Town of Hilton Head Island Regular Design Review Board Meeting

August 28, 2018

AGENDA

TOWER ELEVATION

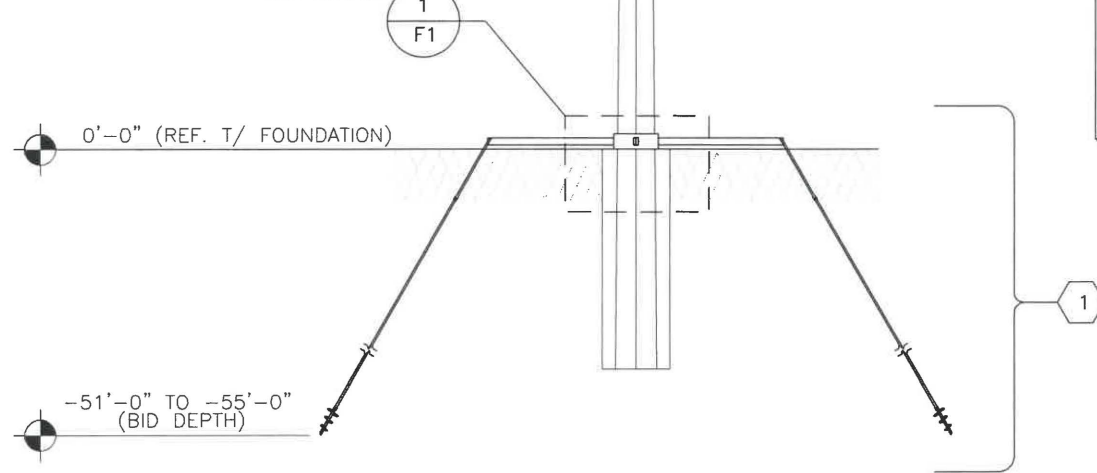
1. The monopole structure shall be painted light blue to match the adjacent existing water tower.
2. Provide a Landscape Plan to replace the vegetation removed to install the footer and pole after the pole is removed to be reviewed and approved by Staff.

First Floor Plan

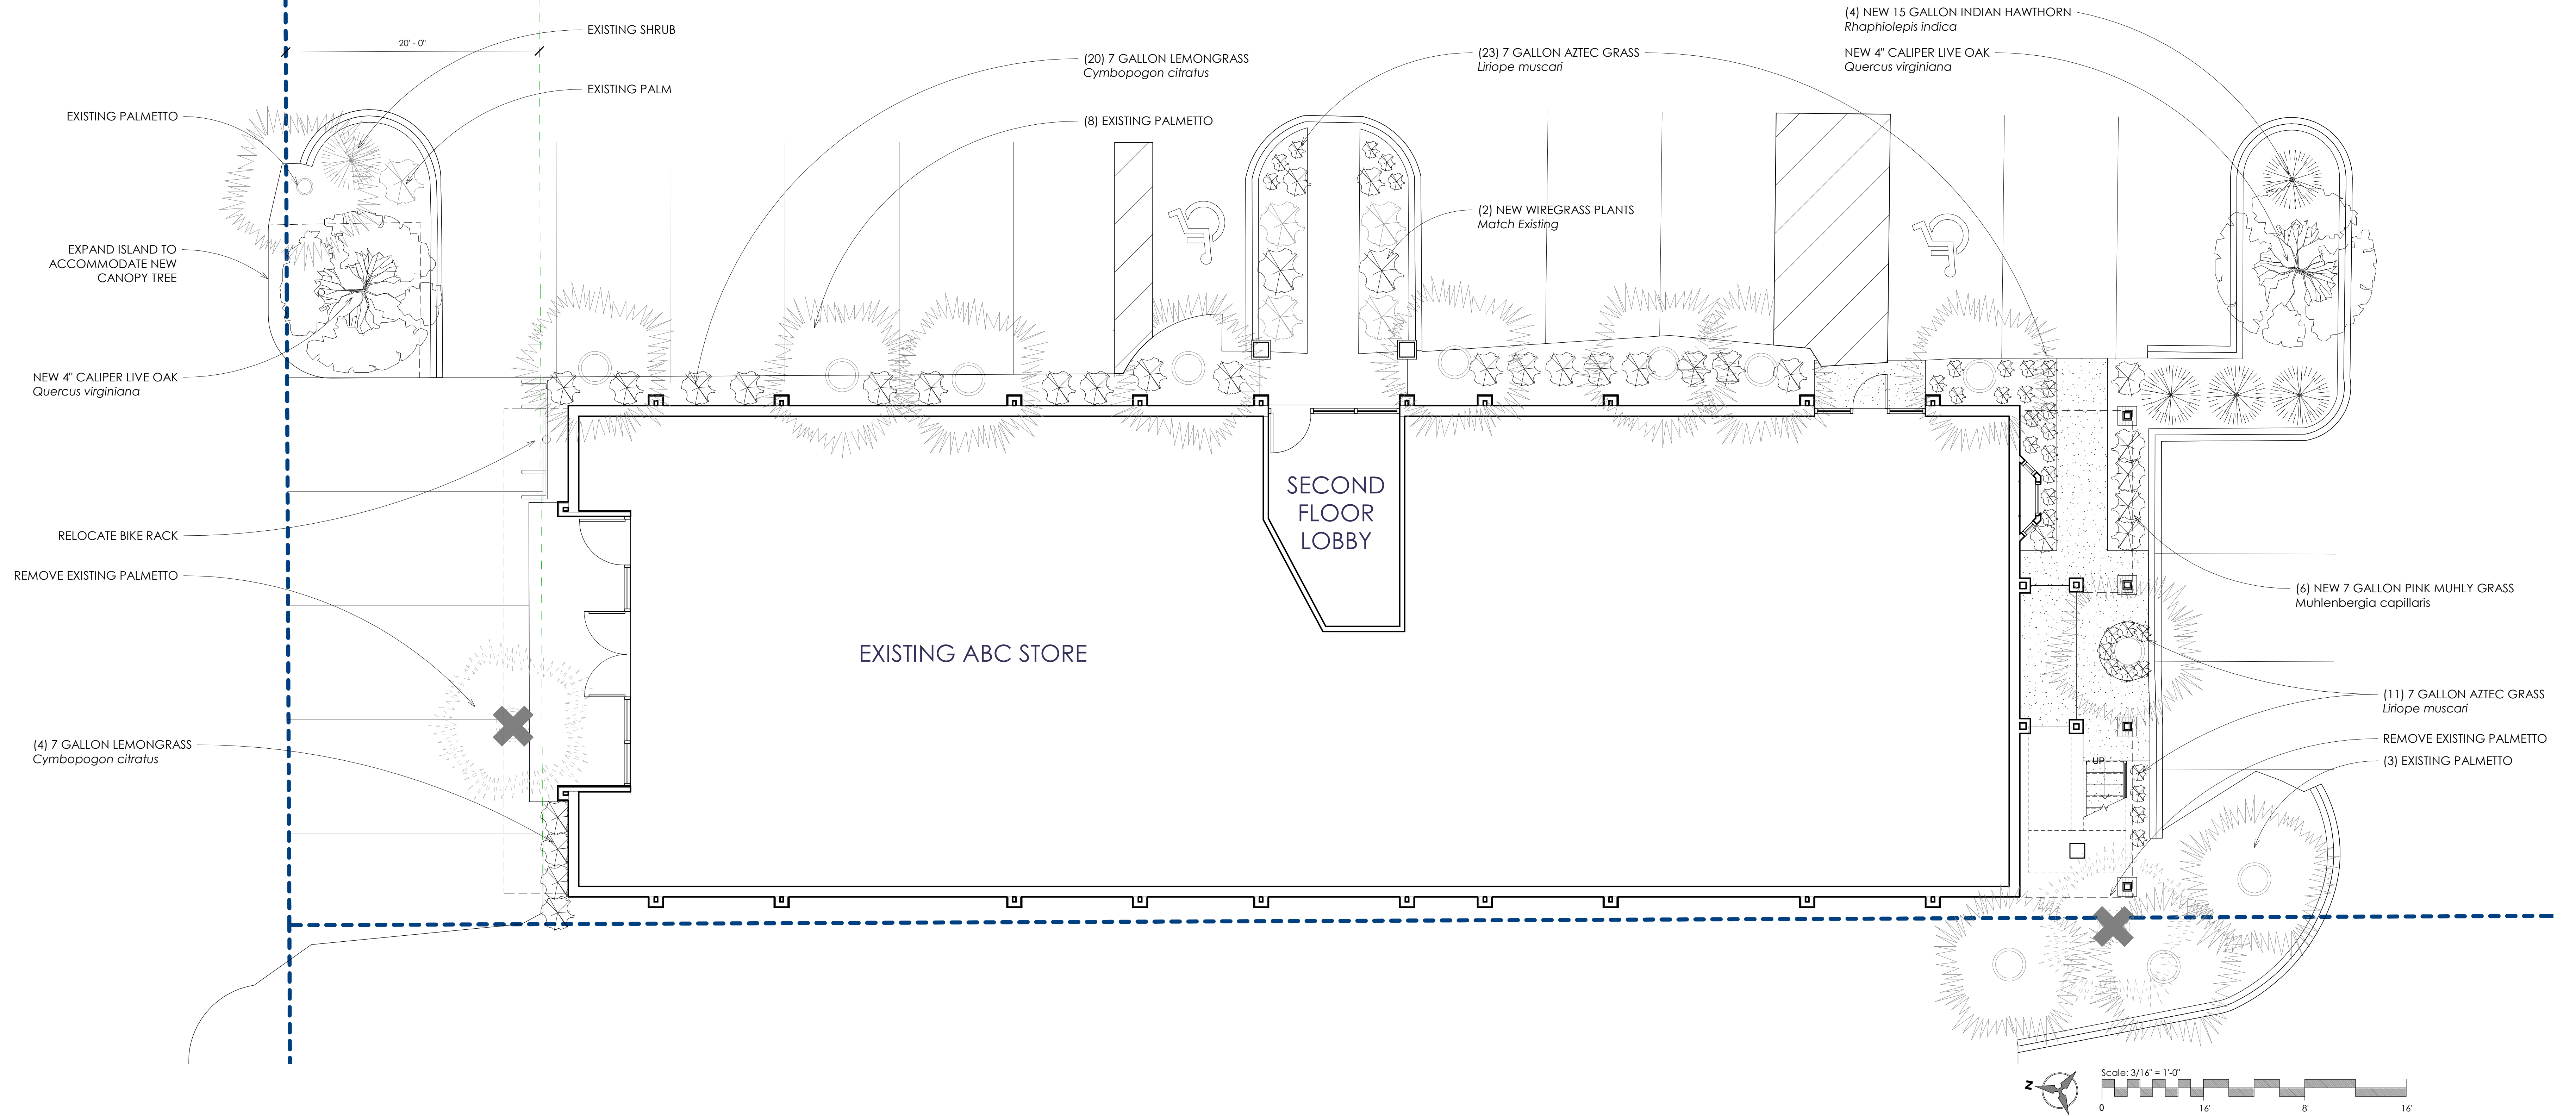
1. Show 20' street setback off Lagoon per LMO 16-3-105.B.3 (Balcony may occupy the Street Setback) **Added.**
2. The project requires a Minor DPR.
3. Provide a Landscape Plan. **Done.**
4. Revise the site plan to show, at a minimum the middle of Lagoon Road. **Done.**
5. The privacy screen seems out of place on the Coligny Plaza elevation. **Revised.**
6. Remove asphalt to reconfigure and clarify the landscape island at Lagoon. Planting should include a Live Oak. **Done.**
7. Remove the sidewalk in the island on the Coligny Plaza end of the building. Planting should include a Live Oak. **Done.**
8. Staff does not support changing the wood shingles to asphalt shingles. Consider another material to replace the wood shingles. **In reconsideration of the context, given the prevalence of green asphalt shingles at Coligny, Staff supports approval of the shingles currently on the building.**

Replace existing cedar shake roof with new 'shake' architectural shingle matching existing Coligny Plaza standard mansart

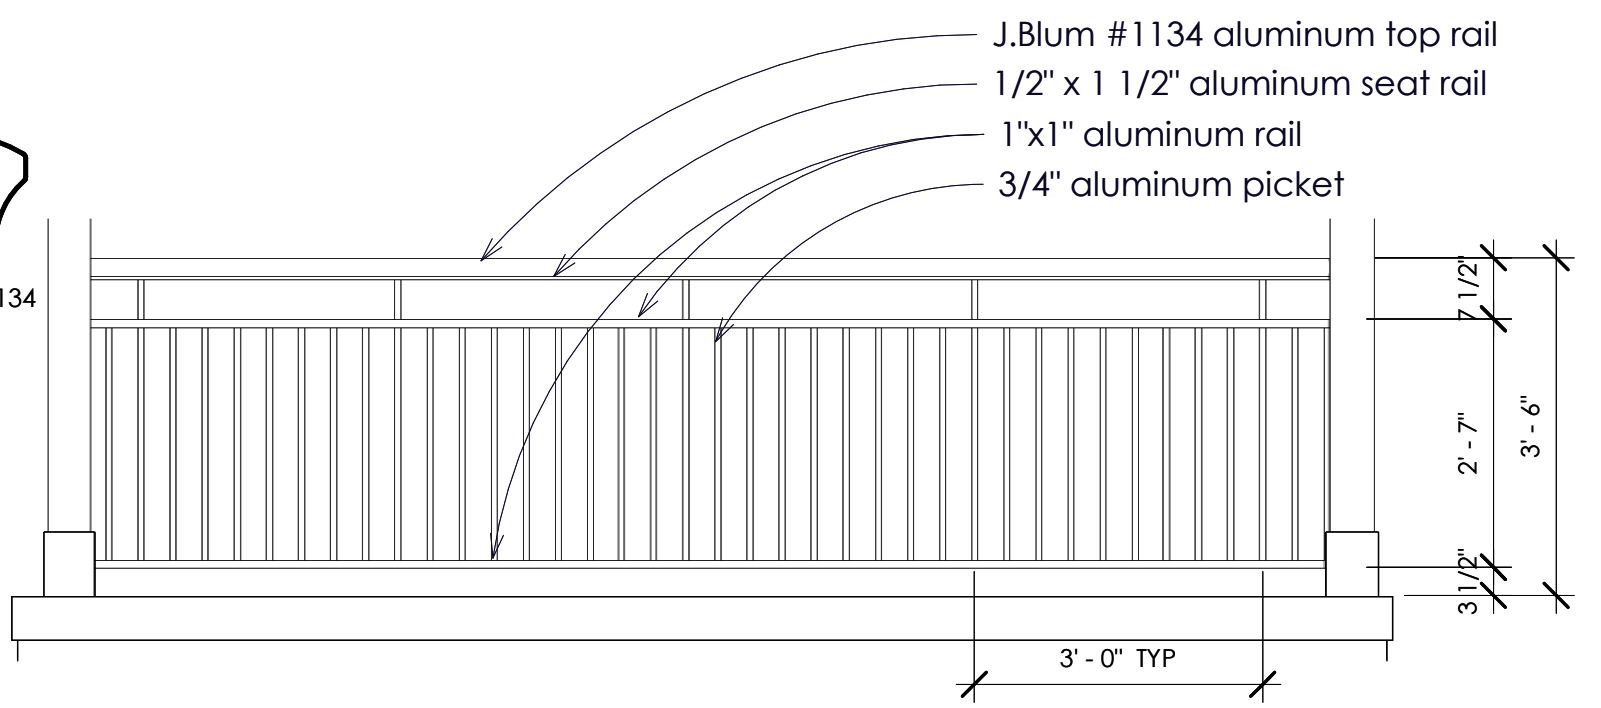
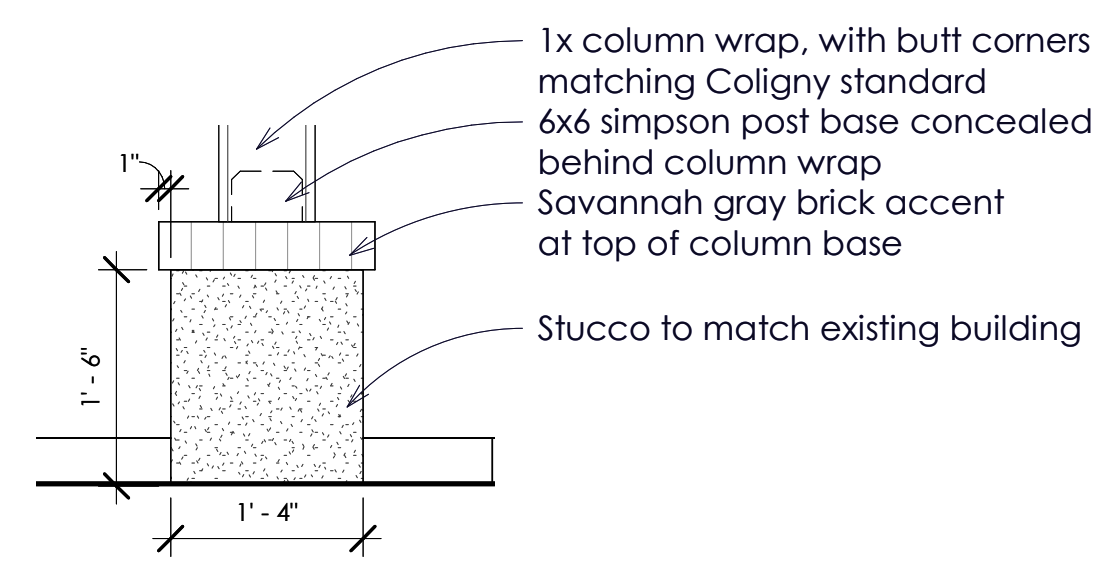
<i>ARCHITECTURAL DESIGN</i>				
DESIGN GUIDE/LMO CRITERIA	Complies Yes	No	Not Applicable	Comments or Conditions
Utilizes natural materials and colors	<input type="checkbox"/>	<input checked="" type="checkbox"/>	<input type="checkbox"/>	Specify the color of all new additions to the building.
Has a strong roof form with enough variety to provide visual interest	<input type="checkbox"/>	<input checked="" type="checkbox"/>	<input type="checkbox"/>	Revise the bay window roof to better coordinate with the new architectural detail additions. Done.
